ANN ARBOR HISTORIC DISTRICT COMMISSION

Staff Report

ADDRESS: 544 Third Street, Application Number HDC14-198

APPLICATION: The applicant seeks HDC approval to remove a rear porch that is partially enclosed and replace it with an enclosed porch in a slightly larger footprint.

Drawing 2. Proposed new view from west. Roof of new porch will be raised to meet kitchen roof. New window will be a slider that looks like the window on the north side of the previous kitchen addition (see photo 2).

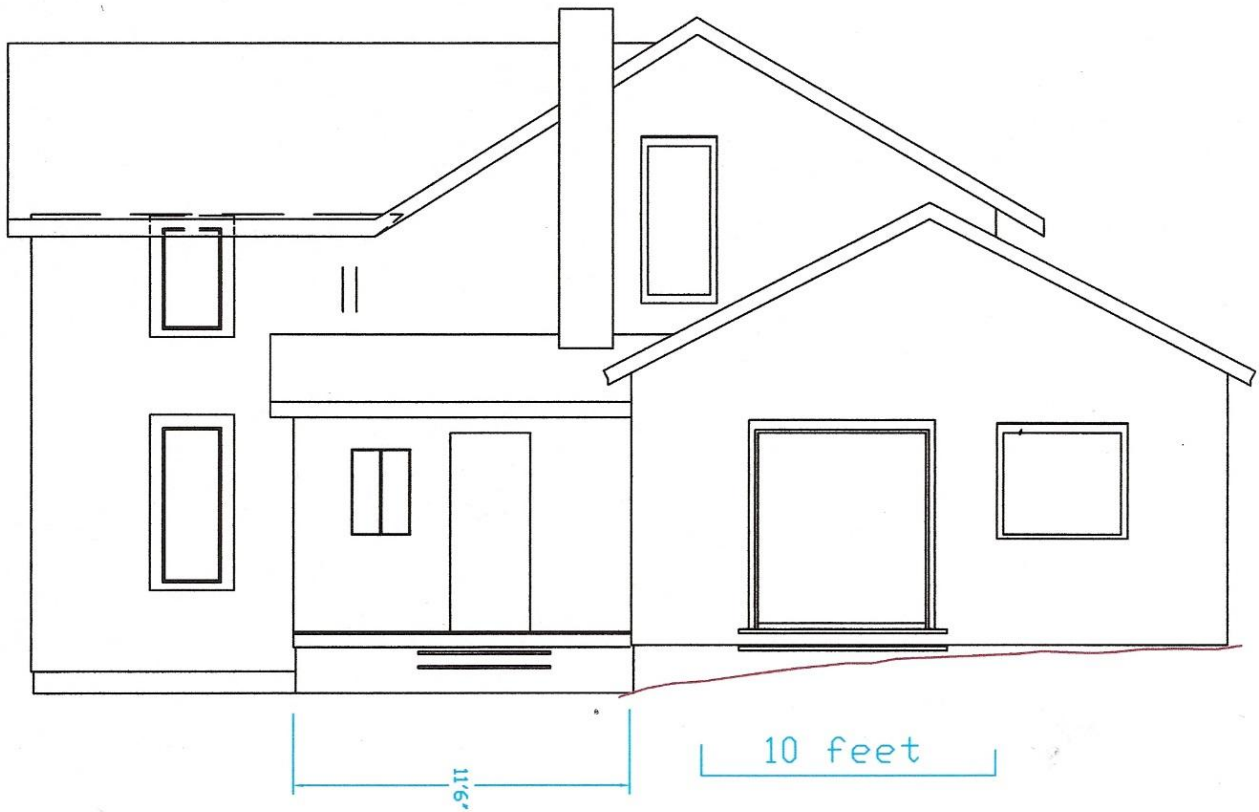
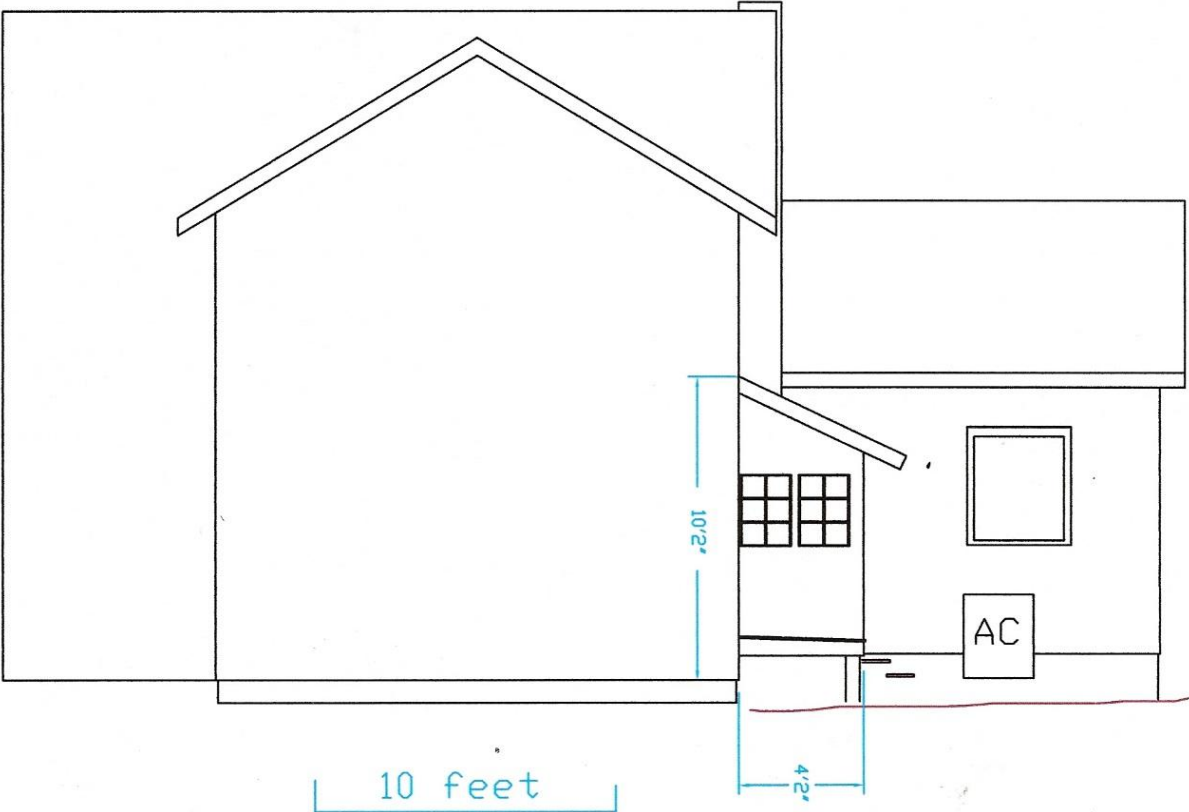
1. It is likely that the location of the door opening into the back wall of the house is original, though the existing porch would have been added with or after the post-1971 side addition. The porch has no character-defining features. It is partially enclosed with plywood walls, but lacks a door.
2. The porch would be rebuilt in a slightly larger footprint, and extended a little more than 2' to the south to connect to the one-story rear addition. There is currently a dead space between the porch and addition, and by tying the rooflines of the porch and addition together, drainage off the roof can be improved. The new porch would wrap around a brick chimney. The chimney looks modern from the photographs and is assumed to be another post-1971 addition. The new porch would have one vinyl slider window that matches a nearby window on the one-story addition. Siding would be smooth 10"

Three questions for you. Will you be installing porch skirting when you're done, and if so, what will it look like? (Could be the lattice that's currently there, or something else.) Next, I don't understand the cement board siding. It's vertical siding, but the contractor is ripping it to look more like the asbestos? Would it then be installed horizontally? It's ok if you want to simulate the asbestos, but don't feel like you have to. Lap siding or even vertical would probably be fine too. Finally, do you have dimensions for the new slider window?

3. The new window would be 3' high x4' wide, very close to the dimension of the combined current windows - i.e., the outer perimeter of the double window - on the front of the porch. We need this light because there would be no window on the north side.
